PRODUCT ADVISORY

Data Sheet Specification Update for Intersil Product ISL59310

**Refer to:
PA11046**

Subject: **Data Sheet Specification Update for Intersil Product ISL59310***

Incorrect POD – PA11046

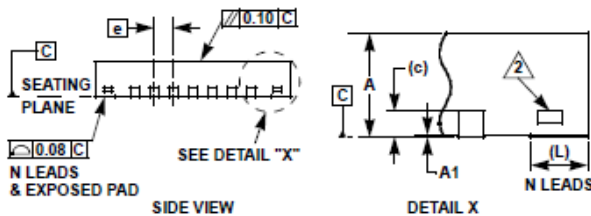
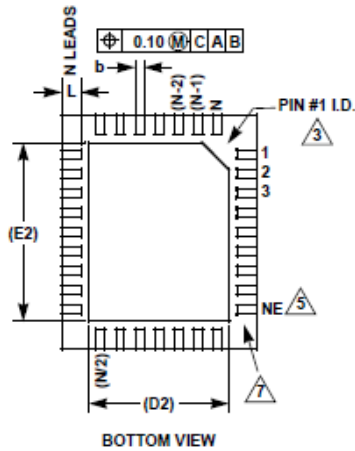
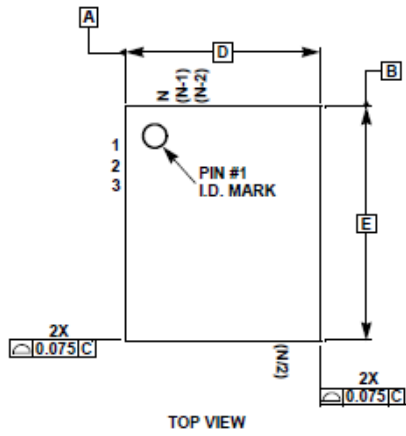
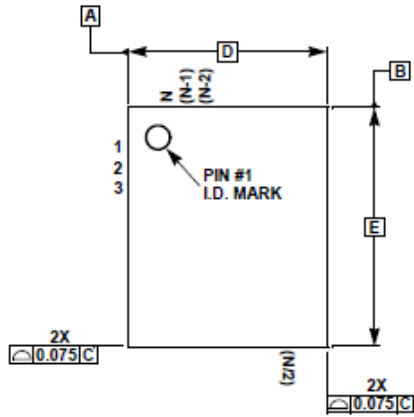
This advisory is to inform you that Intersil has updated the POD (Package Outline Drawing) referenced in the data sheet specification for the listed Intersil ISL59310* products. The updates to the POD correct the minimum and maximum lead width (symbol “b”) dimensions. There have been no changes to the package or product itself. The updated data sheet is available upon request.

SYMBOL	MILLIMETERS			NOTES
	MIN	NOMINAL	MAX	
A	0.80	0.90	1.00	-
A1	0.00	0.02	0.05	-
D	5.00 BSC			-
D2	2.48 REF			-
E	6.00 BSC			-
E2	3.40 REF			-
L	0.45	0.50	0.55	-
b	0.20	0.22	0.24	-
c	0.20 REF			-
e	0.50 BSC			-
N	32 REF			4
ND	7 REF			6
NE	9 REF			5
